RE: Final Environmental Assessment for the Proposed Royal Lahaina Resort Revitalization Project located at TMK: 4-4-008: 007 and 013, Kaanapali, Lahaina, Island of Maui, Hawaii (EA 2005/0014) (SM1 2005/0038) (SSV 2005/0005)

***Final  
Environmental Assessment  
in support of  
Applications for a  
Special Management Area  
Use Permit and Shoreline  
Setback Variance***

**ROYAL LAHAINA  
RESORT REVITALIZATION**

Figure 3

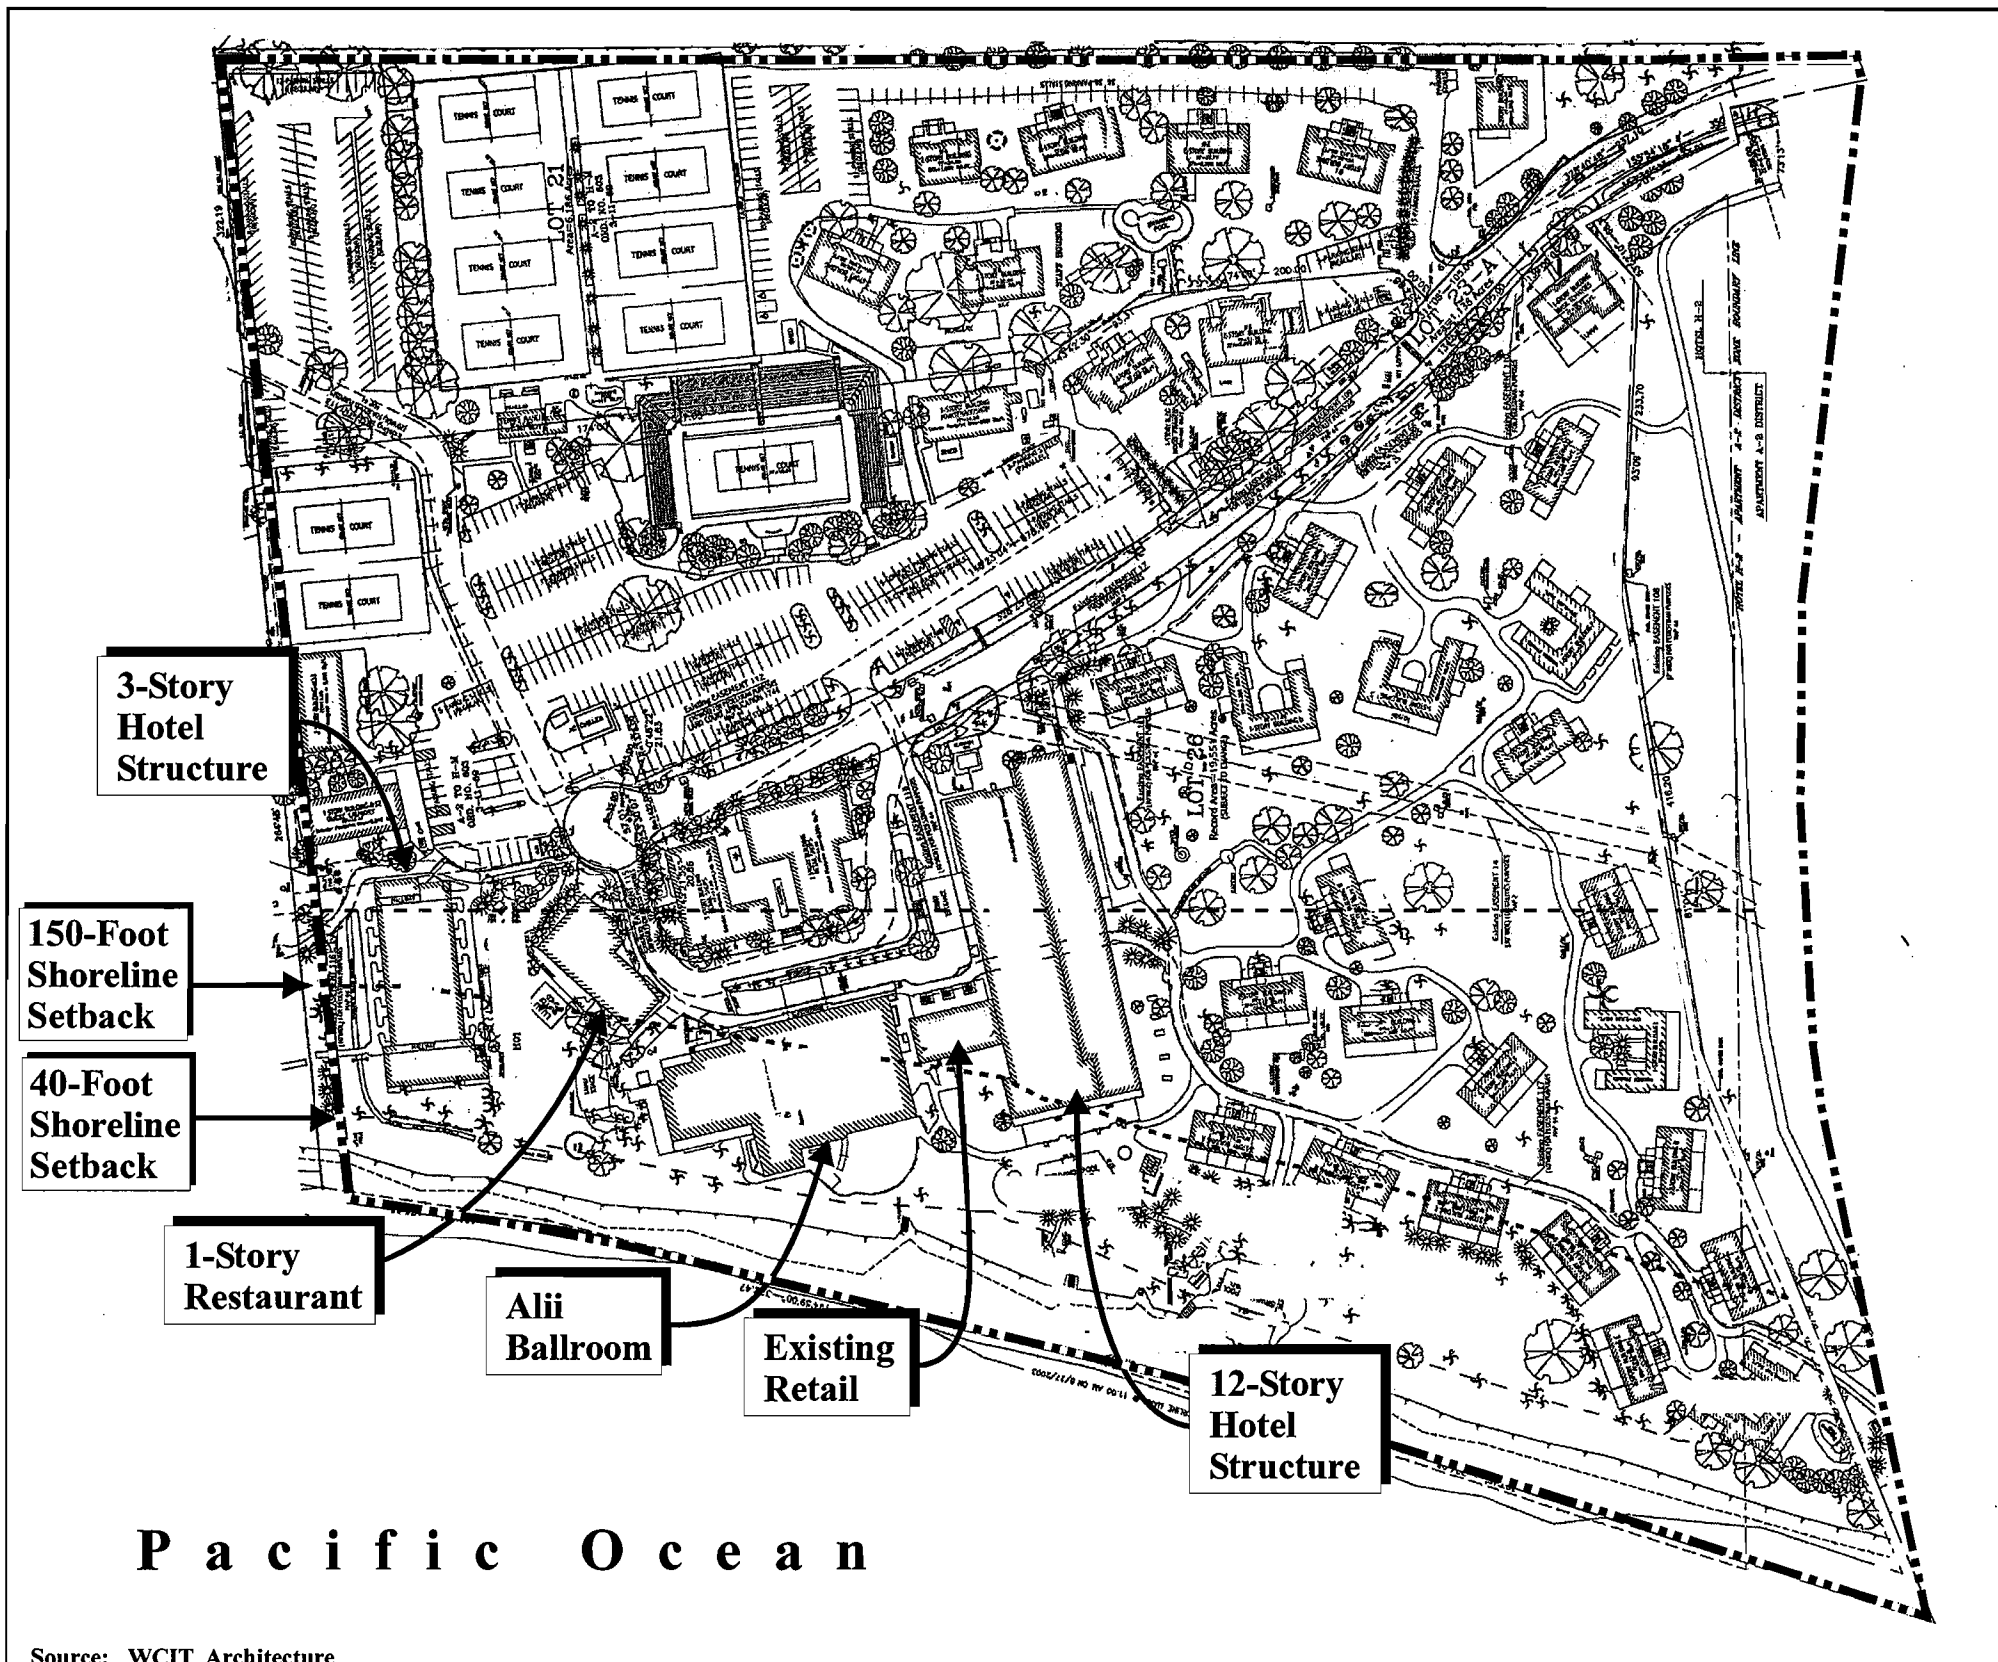
**Shoreline areas:** Figure 3 shows two shoreline areas, labeled as the 40-foot setback and the 150-foot setback. Is the 150-foot area possibly the SMA boundary? Correct or clarify this in this figure and on Table 1.

3. We note your comment with regards to the labeling of Figure 3 and the 40-foot and 150-foot shoreline setback areas. It is noted that these are not the Special Management Area boundaries. The 150-foot setback is the County of Maui Shoreline Setback Area, while the 40-foot boundary is the setback limit for structures along the shoreline.
